DATE: 08/02/2024
TO: All Bidders
FROM: David Cienfuegos, Purchasing Specialist
SUBJECT: Addendum 1 – Bid 677 Ventura College Admin Building Landscaping

PROJECT
 VENTURA COLLEGE
 ADMINISTRATION BUILDING
 LANDSCAPE RENOVATION
 4687 TELEGRAPH ROAD
 VENTURA, CA 93003

DRAWING
L2.1
 SHEET 2 OF 8
 PROJECT No. 23.31

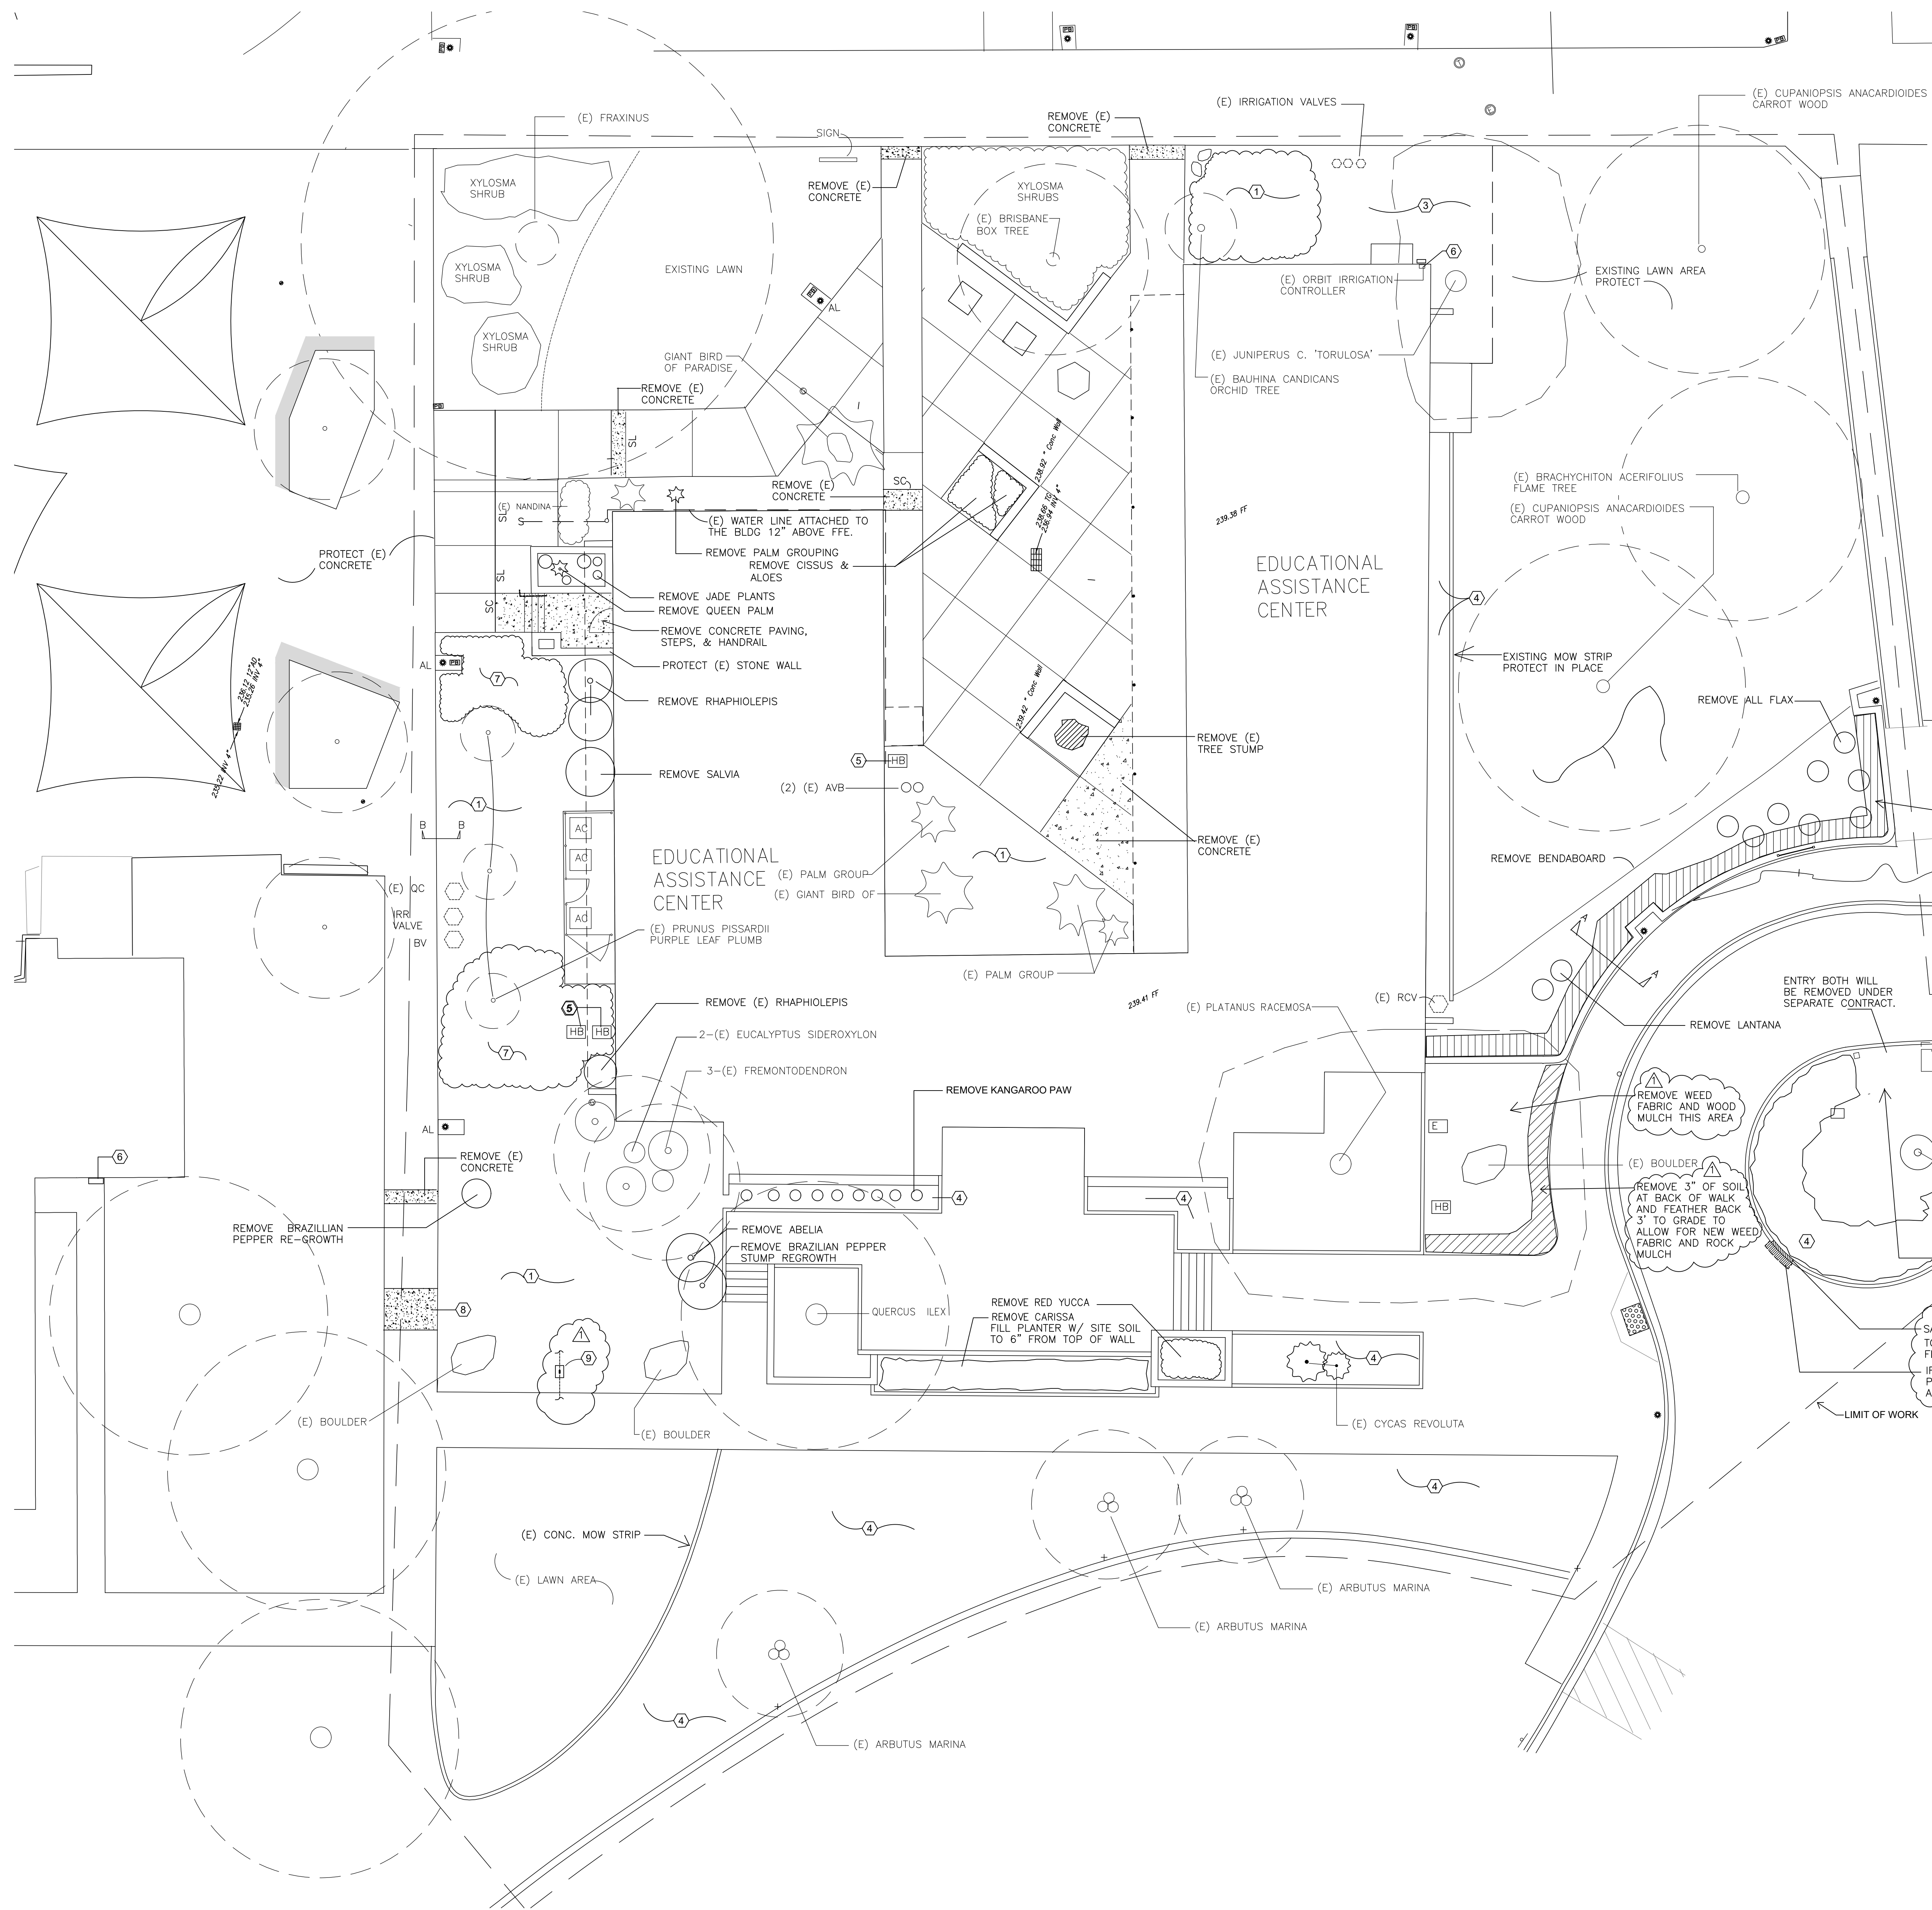
1. L2.1 Landscape and Misc Removals
 - a. Revisions at existing flag pole area including: Slab and footing removal under guard station, removal of soil and preparation of subgrade for new concrete paving around existing flag pole, existing curb saw cutting and removal for new curb ramp installation.

- b. Clarification of soil removal adjacent to walks and walls for the installation of two-inch layer of rock mulch.
 - c. Clarification of Key Notes as related to installation of rock mulch.
 - d. Clarification of soil removals for rock mulch installation.
 - e. Added Key Note no. 9 to fix a leaking ball valve in a two inch potable water line.
2. L3.1 Irrigation Plan:
 - a. Revision of irrigation shrub bubblers around the revised planting at the existing flagpole area.
 3. L4.1 Landscaping Renovation Plan:
 - a. New concrete paving and curb ramp added to the area around the existing flagpole area.
 - b. Clarification of plant legend. Revisions noted.
 - c. Clarification of rock mulch, a two inch layer of rock mulch is to be installed throughout all planting areas.

| NO. | WORK DESCRIPTION |
|-----|---|
| 1 | REMOVE (E) SHRUBS, ROOTS, WEEDS, AND ALL DEBRIS. FINE GRADE TO A UNIFORM SURFACE 3" BELOW ADJACENT CONCRETE. INCORPORATE PRE-PLANTING AMENDMENTS AS PER THE SPECIFICATIONS. SEE SECTION B-B |
| 3 | REMOVE ANY VEGETATION AND SOIL TO ALLOW FOR THE NEW WALK AND THE 3 INCH LAYER OF ROCK MULCH. |
| 4 | REMOVE WEEDS, AND SOIL TO ALLOW FOR THE 3 INCH LAYER OF ROCK MULCH. SEE SECTION B-B |
| 9 | EXISTING 2" DOMESTIC LEAKING WATER LINE AND BALL VALVE IN BOX. REPLACE BALL VALVE AND FITTINGS AS NECESSARY TO FIX LEAKING CONNECTION. |

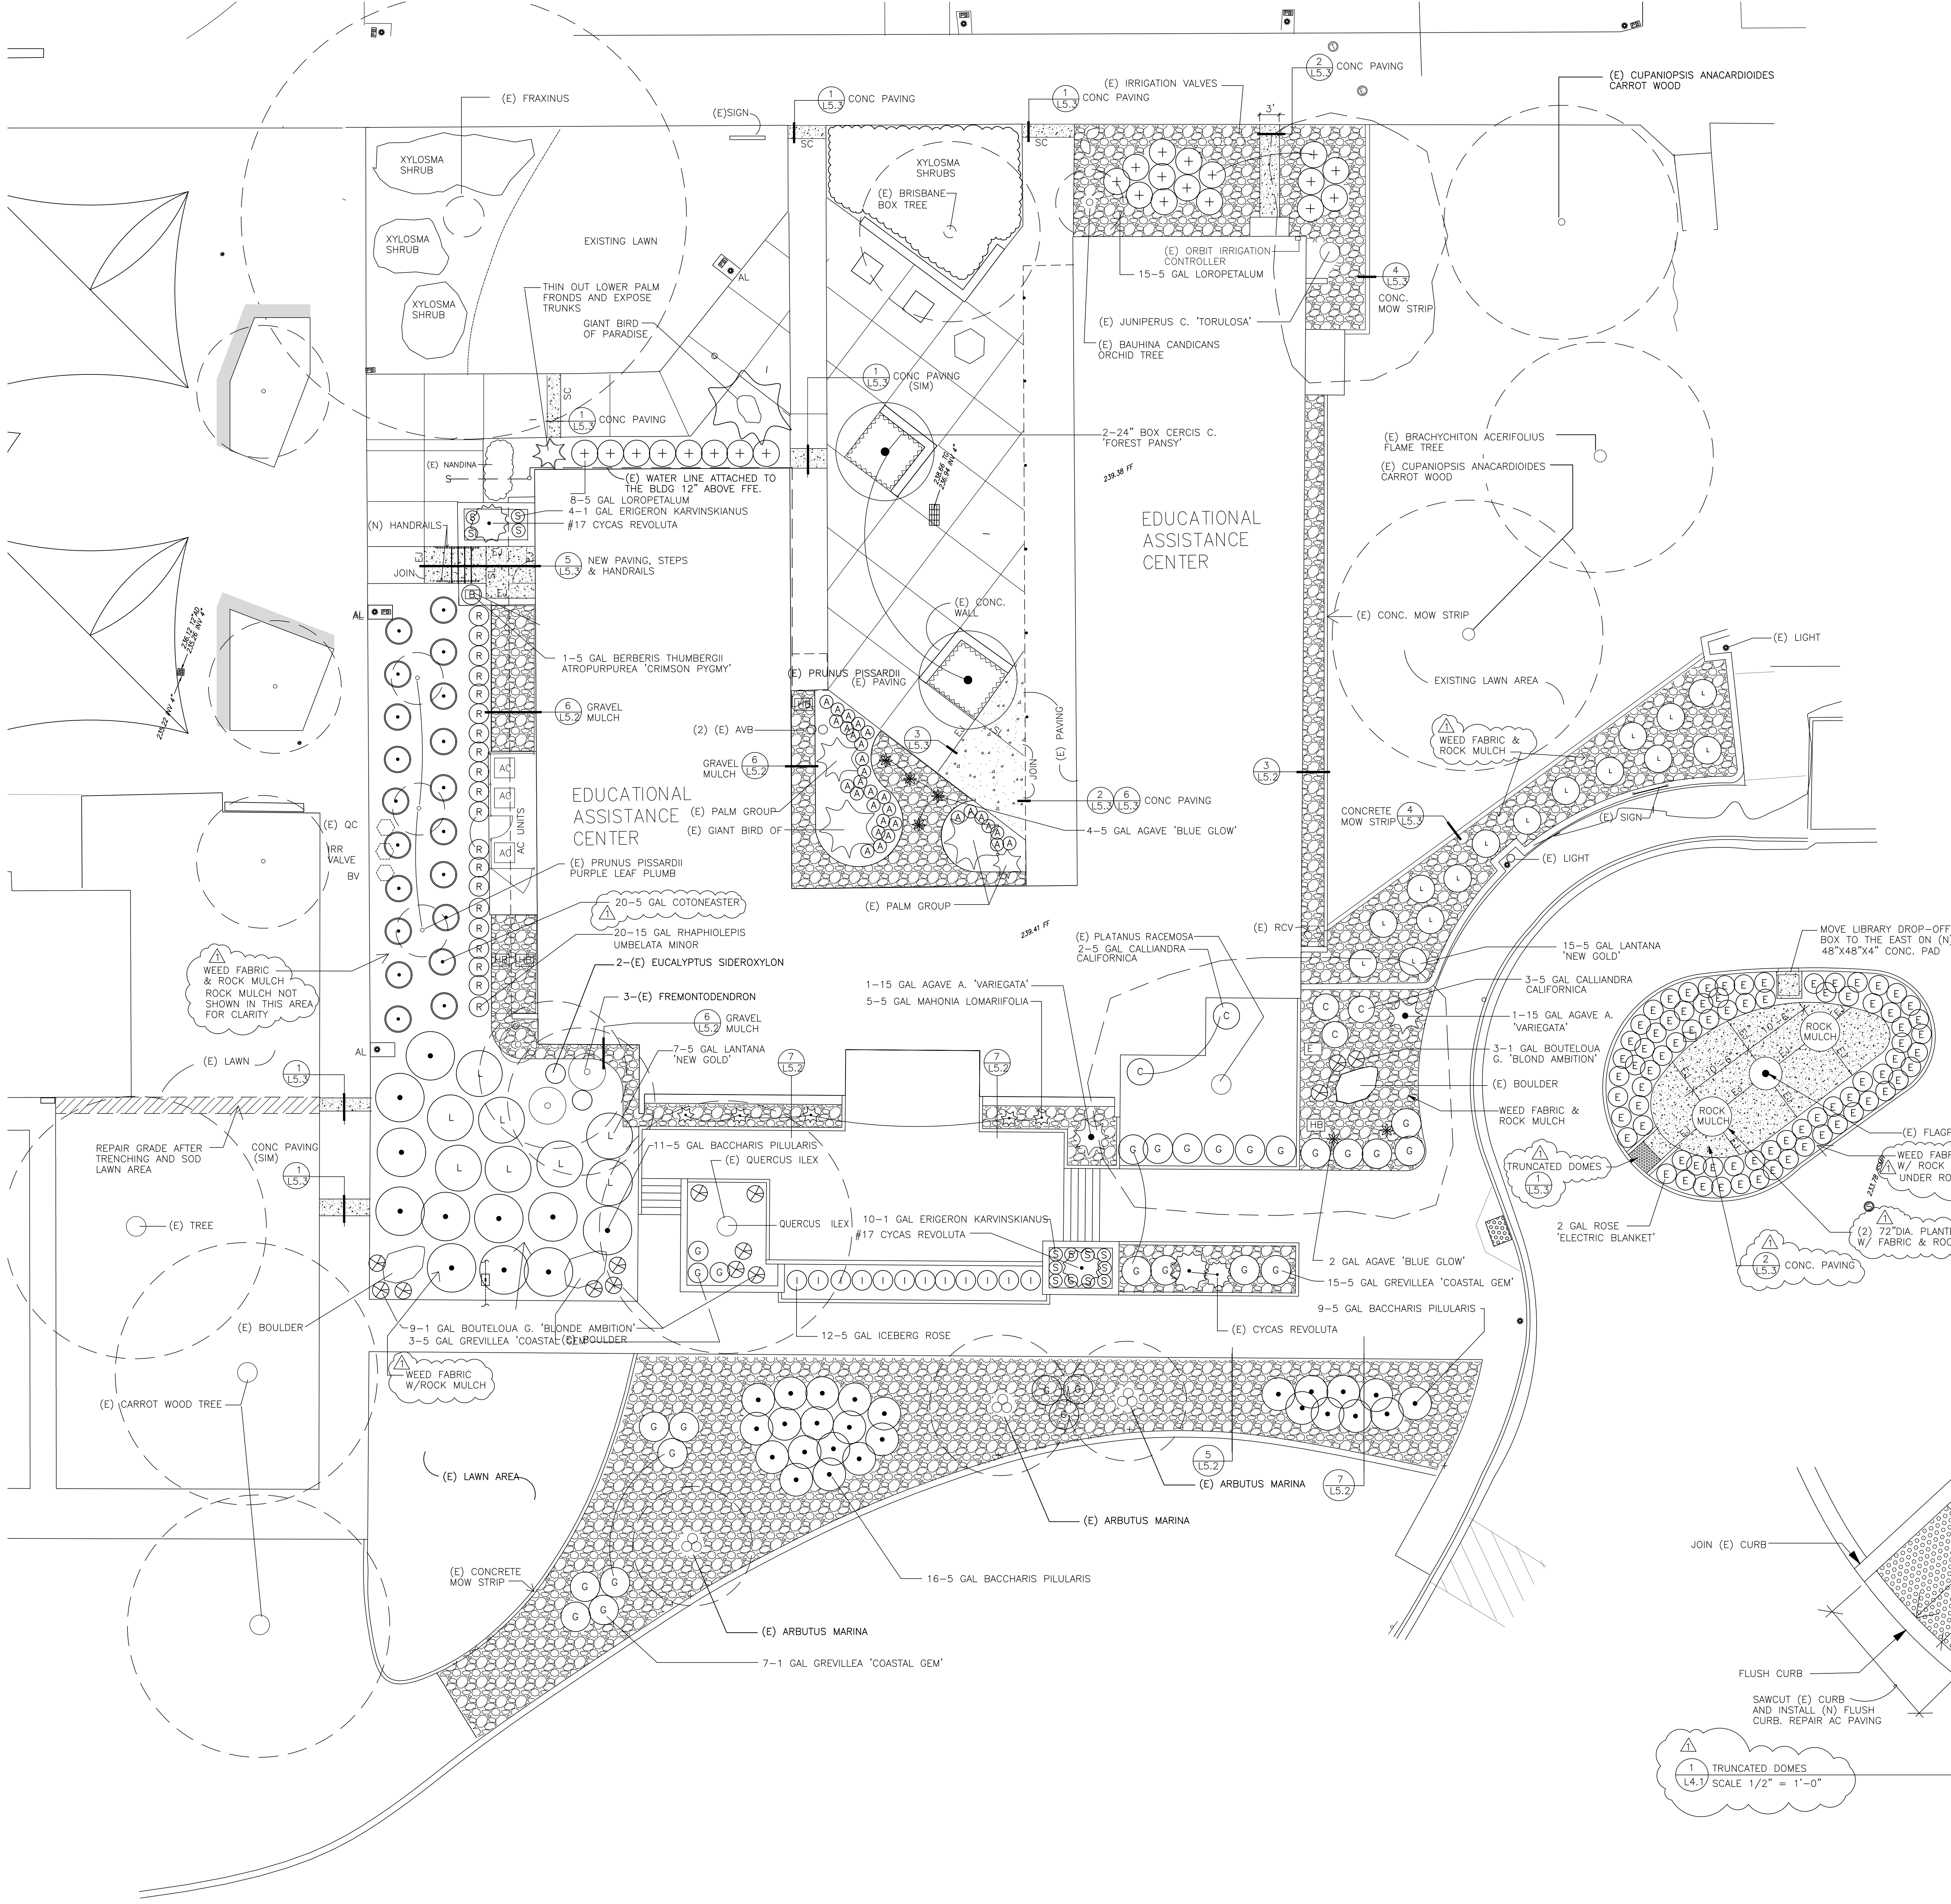
- 1) Can the prime contractor license requirement be revised to include C-27 license holders?
 - a. No. Scope includes work beyond landscape systems, including pavement demolition, concrete placement, and handrails.
- 2) Ref: Drawing L4.1, Sheet 5. There is a callout for 20 x 5 gal Coprosma X. Kirkii variegata plants, the matching symbol in the legend references Cotoneaster "Coral

Beauty”. Please confirm the plant type.

- 10) Planter east of the Educational Assistance Center on sheet L4.1 indicates to install weed barrier without mulch. Please advise if no topdressing with either bark or rock mulch is required.

- a. The legend is correct, install “Cotoneaster “Coral Beauty”. Also at the ADM Building main entry planters, there is a callout for “5-5 GAL MAHONIA LAMARIIFOLIA” but no shown on the legend which is required as part of the contract. Reference updated clouded Sheet L4.1 Admin Planting Plan.

- a. Topdressing to be 2” thick include Del-Rio 3/8 inch rock, reference updated Sheet L4.1 and spec Section 32 93 15.
- 11) Will all bare planting areas not receiving rock mulch need bark mulch? If so, what depth and what type of mulch?

- a. Topdressing to be 2” thick include Del-Rio 3/8 inch rock, reference updated Sheet L4.1 and spec section 32 93 15.
 - 12) Will we be allowed to use a concrete truck on the north walkway?

| SHRUBS SYMBOL | QUAN. | SIZE | BOTANICAL NAME COMMON NAME | DETAIL REFERENCE |
|---------------|-------|-----------|--|------------------|
| (O) | 5 | 5 GALLON | MAHONIA LOMARIFOLIA | |

| SYMBOL | DESCRIPTION |
|--------|--|
| (Q) | 2 INCH LAYER OF 3/8" DEL-RIO PEA GRAVEL OVER WEED FABRIC ALSO IN PLANTING AREAS INDICATED WITHOUT SYMBOL |
